INDESIT company

Model type:
AVSF129EU

Commercial code:
F034047

Fig . 001

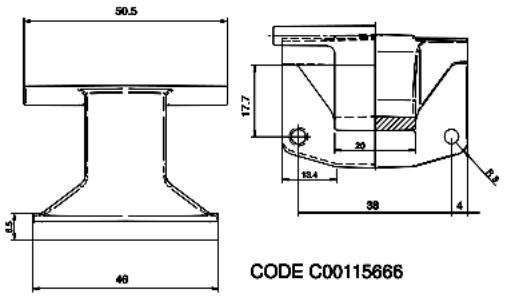
n1040349: Introduction of 150° Zamac hinge on Ariston 46 models.

From serial no. 50207.0001, all Ariston models produced in the Teverola factory (see table 001 attached) with industrial code (given on the rating plate) starting with 46, have been equipped with a Zamac hinge with 150° opening angle, code C00115666

(see Fig.001).
This modification has involved the introduction of the following items:

Code C00115670 - Complete door EVOII 150° white 27 with standard glass;
Code C00115674 - Complete door EVOII 150° white 27 with long glass;
Code C00115667 - EVOII body for 150° hinge white 27;

The premodified items are not interchangeable separately with the modified ones.

Code C00110133 - Complete door EVOII Standard 180° white 27 standard glass;
Code C00092157 - Complete door EVOII 180° white 27 long glass;
Code C00096193 - EVOII body for 150° hinge white 27;

Fig . 001

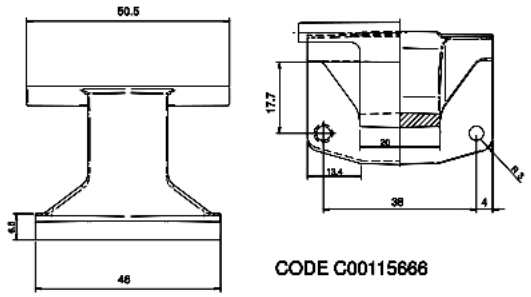
n1040353: Introduction of 150° Zamac hinge on Ariston models (Comunanza).

From serial no. 50207.0001, all Ariston models produced in the Comunanza factory (see table 001 attached) with industrial code (given on the rating plate) starting with 80, have been equipped with a Zamac hinge with 150° opening angle, code C00115666 (see Fig.001).
This modification has involved the introduction of the following items:

Code C00115670 - Complete door EVOII 150° white 27 with standard glass;
Code C00115674 - Complete door EVOII 150° white 27 with long glass;
Code C00115668 - Complete door EVOII 150° silver with standard glass;
Code C00115673 - Complete door EVOII 150° silver snella standard glass;
Code C00115662 - EVOII body for 150° hinge white 27
Code C00115663 - EVOII body for 150° hinge silver 27
Code C00115664 - Snella EVOII body for 150° hinge white 27
Code C00115665 - Snella EVOII body for 150° hinge silver

The premodified items are not interchangeable separately with the modified ones.

Code C00096416 - Complete door EVOII LB 180° standard depth silver;
Code C00097374 - Complete door EVOII 180° WD 180° white 27 long glass;
Code C00110133 - Complete door EVOII Standard 180° white 27
Code C00110178 - Complete door EVOII Snella 180° Silver;
Code C00091836 - EVOII body white 27 for 180° hinge;
Code C00094306 - EVOII body silver for 180° hinge;
Code C00094305 - Snella EVOII body white 27 for 180° hinge;
Code C00094307 - Snella EVOII body silver for 180° hinge;

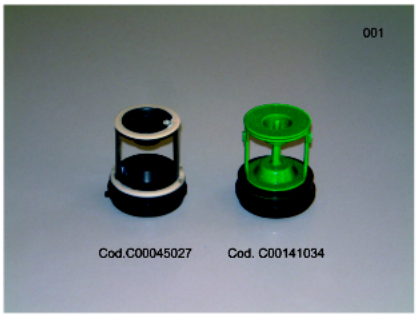
n1040376: Drain pump with filter with pin.

A new drain pump with filter with pin has been introduced progressively as from serial no. 50609.0001.

New parts:
C00119307 - Drain pump with pin filter;
C00141034 - Askoll / Plaset drain pump with pin filter kit (figure 001);

Premodification parts:
C00092264 - Drain pump;
C00045027 - Askoll / Plaset pump filter kit (figure 001);

The new parts can be used on all WASHING MACHINES previously equipped with the premodification parts.
